RECOMMENDATION MEETING

**5206 17th Avenue NW
Seattle, WA 98107**

3039194-LU

08.21.2023

EXHIBIT 11 - PREFERRED LANDSCAPE DESIGN | “SALMON LADDER”

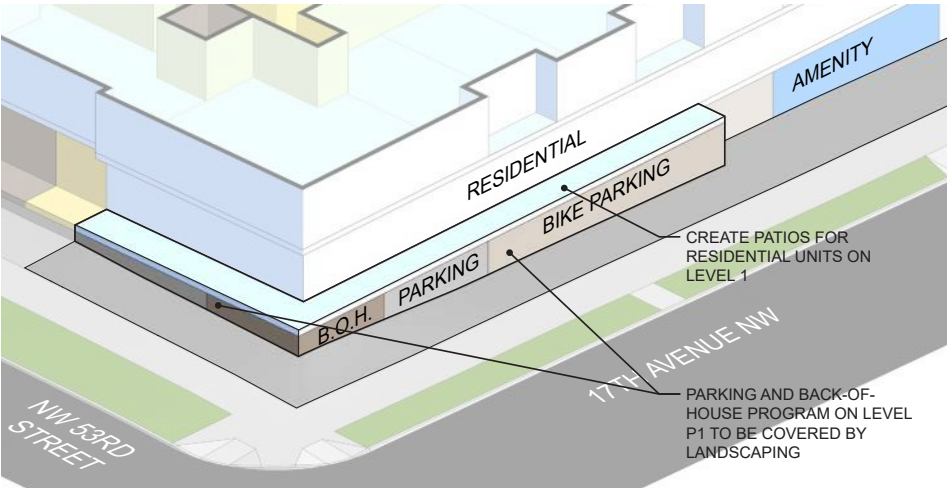
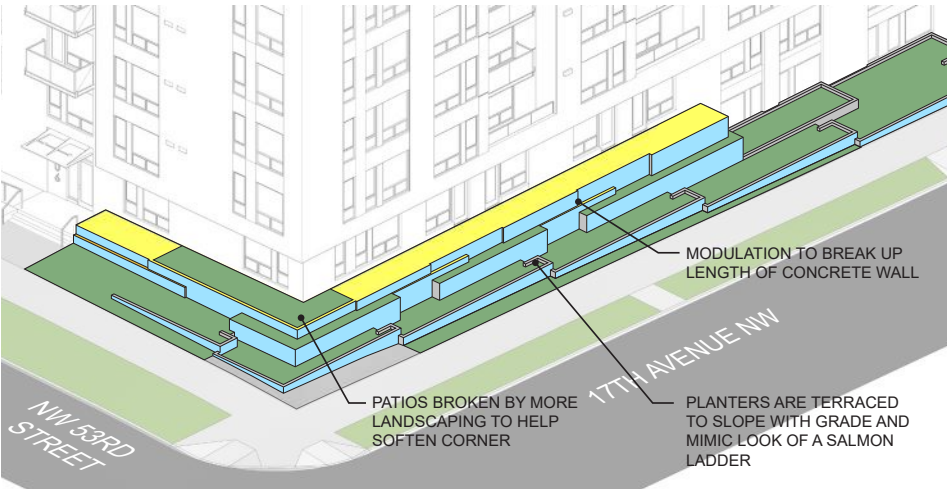
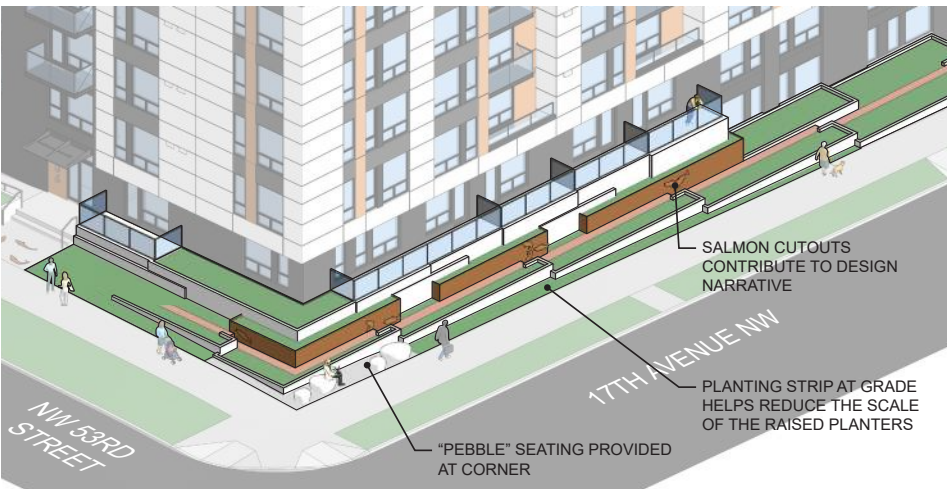
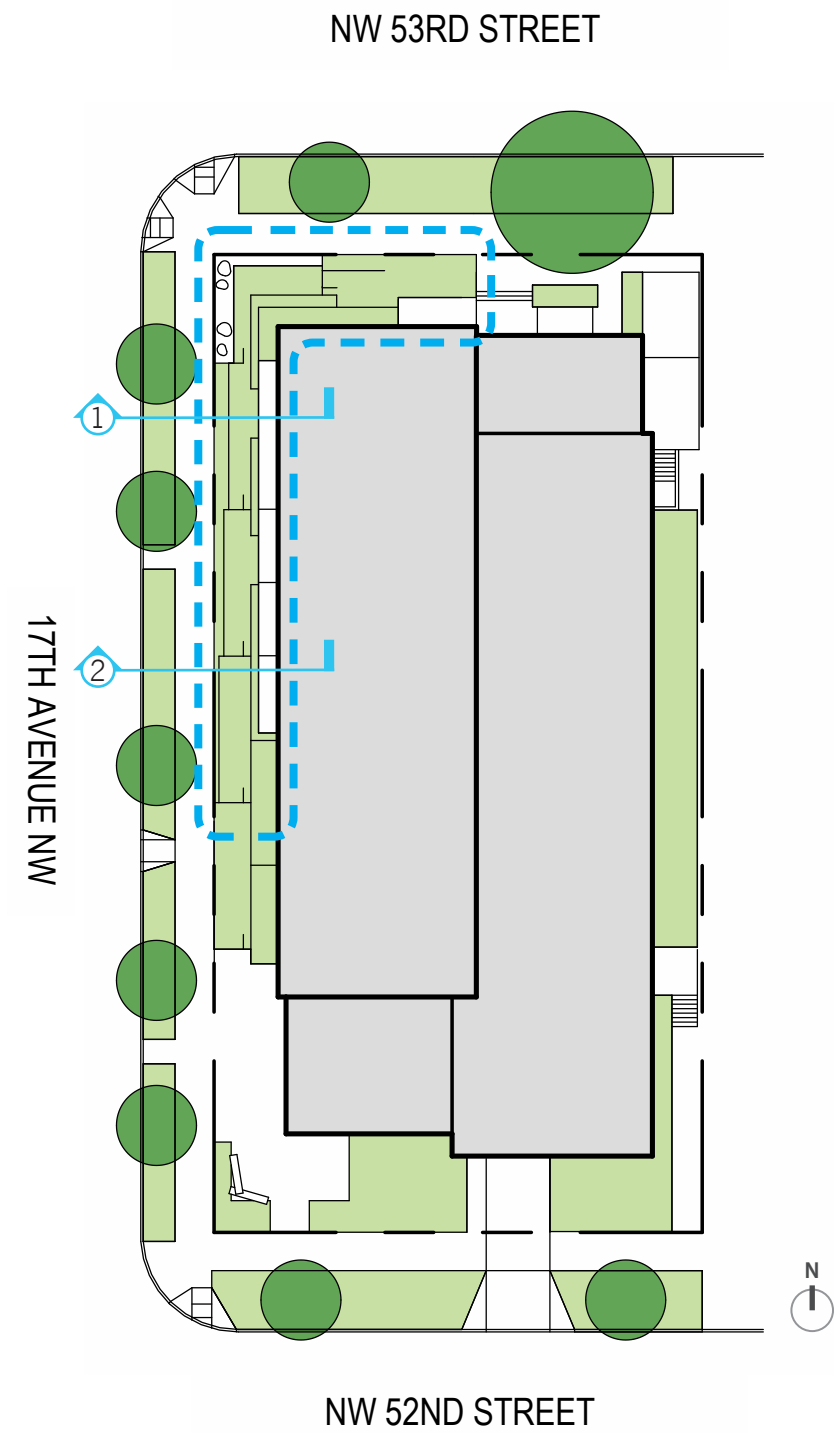
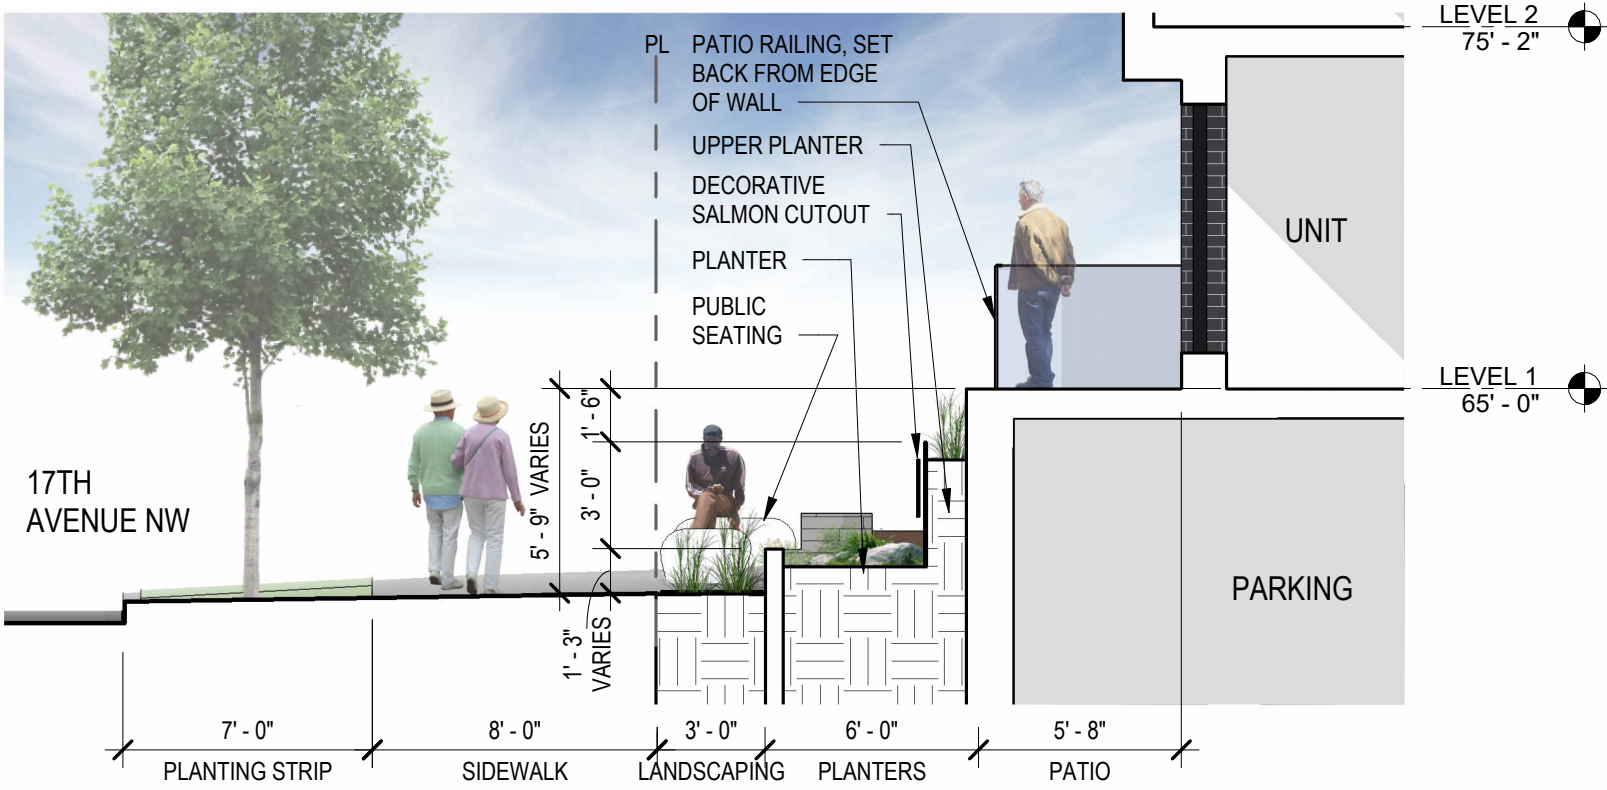
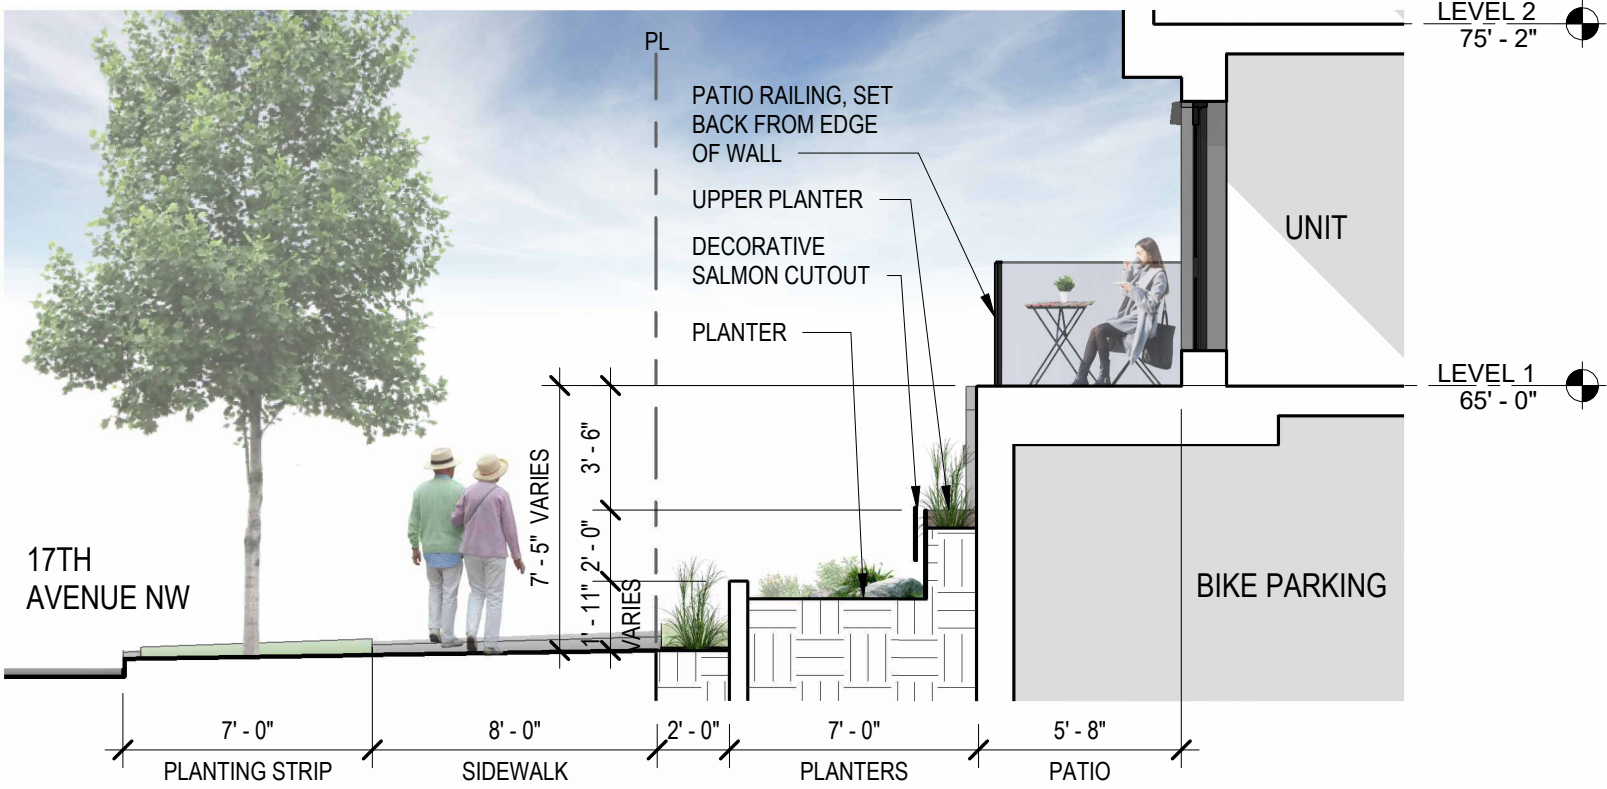
The Board asked about the height of the separation of the first level units to the sidewalk grade along the 17th Ave NW frontage. The applicant noted that as the parking and service are tucked into the slope of the site and are partially underground, the first level ranged from 3-5’ above the grade along the west frontage. The Board noted that elevated terraces could activate the streetscape but asked for further refinement of the design of the terracing, especially as they can be related and integrated into the language of the architecture. At the Recommendation phase of review, the Board would like to see studies showing how private patios will activate the streetscape. PL3-2 Residential Edges, DC3-3-a. Amenities and Features, PL1-1-b. Adding to Public Life, CS1-C Topography

Exhibit 11 shows how the proposed patios along 17th Avenue NW relate to the adjacent sidewalk. Public seating with artwork are proposed along the sidewalk to enhance the pedestrian experience while ample landscaping softens the building’s edges and helps mask the patio and parking garage walls. An alternate scheme with stairs leading to the four patios was studied and included in the package. The stairs have some added benefits of street activation, but are ultimately tall and visually push the building closer to the sidewalk. Additionally, they conflict with the envisioned “salmon ladder” scheme and consequently have a different landscape designed around them. Lastly, patio stairs elicit security concerns for ground-level occupants and the design team does not wish to condone their inclusion in the project if a better alternative can be found.
